## Drilling/Casing Change

SUNDRY NOTICES AND REPORTS ON WELLS

Chacon Jicarilla 602H

Based on a gyro-directional survey conducted on the Chacon Jicarilla D #13, Energen would like to move the SHL of the Chacon Jicarilla #602H to 892' FSL, 775' FWL. See attached Amended C-102.

**Plan: Design #1**

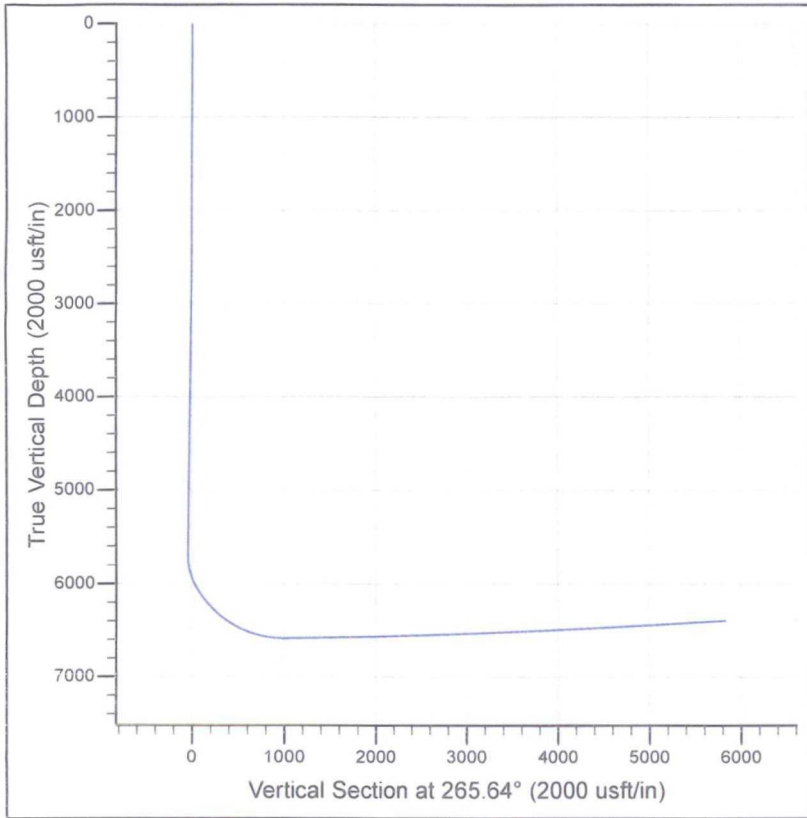
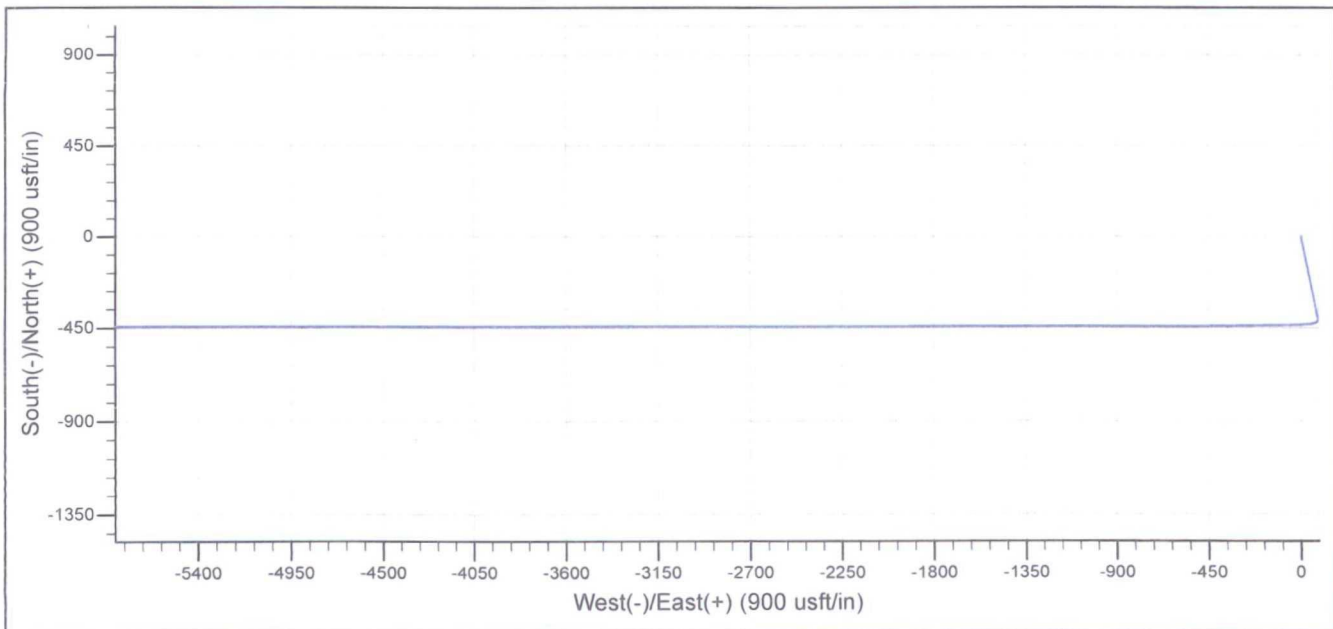
- Drill thru in a manner to achieve an optimal departure to log and core the Mancos. See attached directional plan.
- Plug back the drill thru to a KOP of 2888' TVD.
- Build and land the curve.
- Set conductor casing- 13-3/8", H-40, 48#, to 200'MD/200'TVD.
- Change 9-5/8" csg Grade to K-55, set depth at 2000'MD/2000'TVD. Change 4-1/2" from 7050'-12025'MD/5492'-6454'TVD to 7100'-12085'MD/5492'-6454'TVD.
